Informal document **GRSP-50-25**  
(50th GRSP, 6–9 December 2011,  
agenda item 13)

# Evaluation of belt guide and inflatable child seat systems

Farid Bendjellal, Michael Grohspietsch  
5th December 2011

**Figure 2a: Time 0 ms – Initial P10 dummy position**

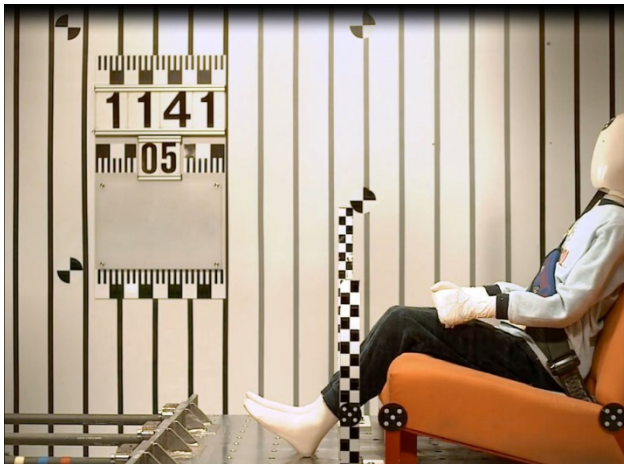
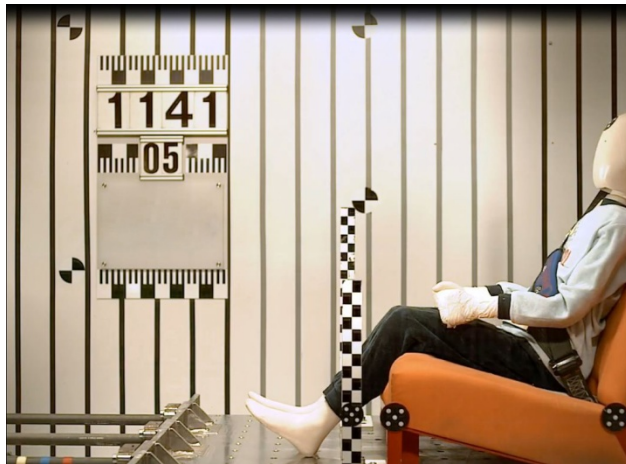
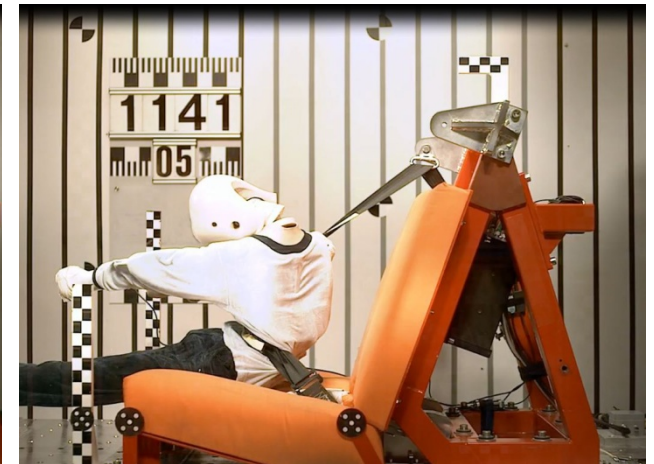
The kinematic of the occupant shows that the lap portion of the seat belt is intruding into the abdomen of the dummy, which is a clear indication of a severe submarining (Figure 2 a/b/c).

This major shortcoming of such systems is that they can't maintain belt geometry for a proper restraint of the child

- For group I the system does not comply with the requirements of §6.1.12 of R44/04.
- For group II/III the lap portion of the belt intrudes into the abdomen of the dummy, leading to a submarining situation.
- That means the system does not comply with § 6.2.4.  
§7.1.4.3.1
- The major shortcoming of such systems is that they can't maintain belt geometry for a proper restraint of the child.
- *“ 6.2.4. The assembly shall not subject weak parts of the child's body (abdomen, crotch, etc.) to excessive stresses. The design shall be such that compression loads shall not be imposed on the crown of the child's head in the event of a collision” .*

**Figure 4a: Time 0 ms – Initial P10 dummy position**

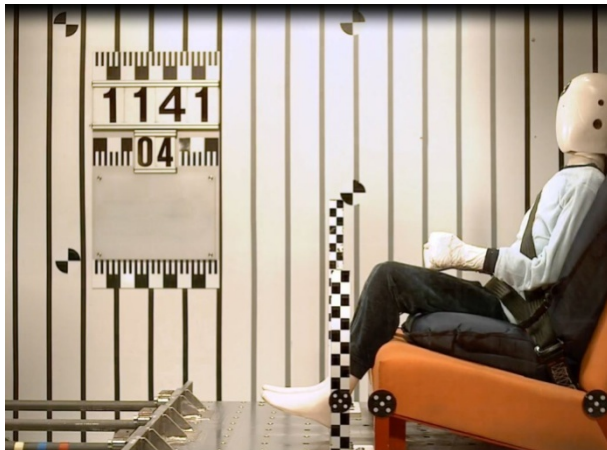
The kinematic of the occupant is illustrated in Figure 1, with 3 sequences selected from the test video. It shows that the lap portion of the seat belt is intruding into the abdomen of the dummy, which is a clear indication of a severe submarining (Figure 4 a/b/c).

- The lap portion of the belt intrudes into the abdomen of the dummy, leading to a submarining situation.
- That means the system does not comply with §6.2.4 and §7.1.4.3.1 of R44/04.
- The major shortcoming of such systems is that they can't maintain belt geometry for a proper restraint of the child.
